UNITED STATES PATENT AND TRADEMARK OFFICE

Office Action Summary

10/729,086

DETAILED ACTION

FIG. -3

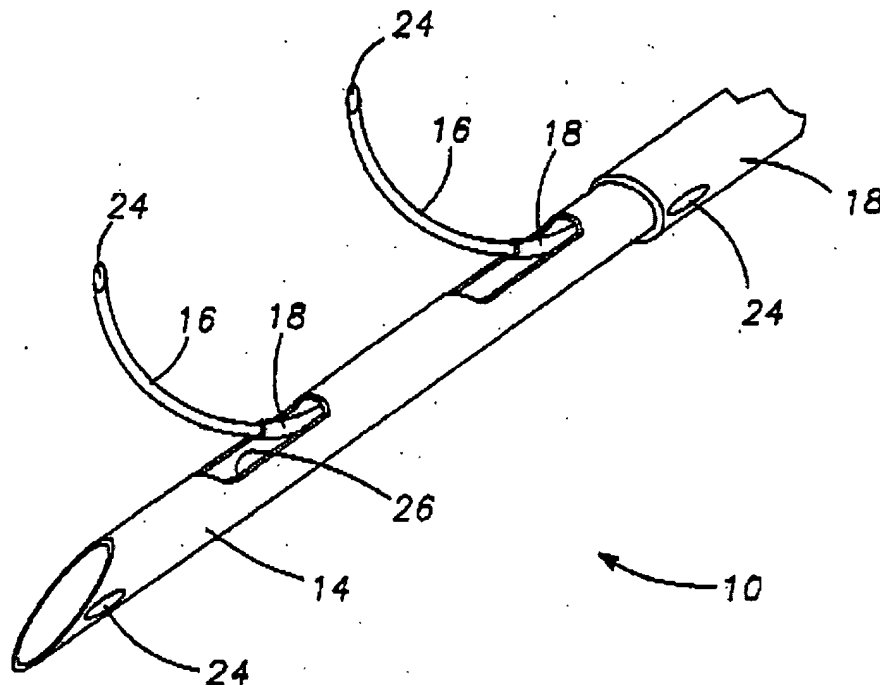
In regard to claims 37-39, Gough et al. disclose the features of the Applicant's invention as described above including a node accessing and anchoring device (10) comprising an elongated shaft (18) having an inner lumen, a distal end (14), a proximal end, a longitudinal axis, a radially

extending anchoring element (16) and a tissue cutting member located at the distal end of the shaft as shown in Fig. 3.

The Gough et al. device includes at least one anchoring element having a retracted configuration and an extended configuration (col.7; col. 8, lines 1-54). Although Gough et al. disclose having sensors other than thermal sensors as a detector located within the inner lumen of the elongated shaft, Gough et al. do not disclose the device having a radiation detector to detect radioactive material from the lesion site. Ritchart et al. disclose a device for collection of soft tissue. The
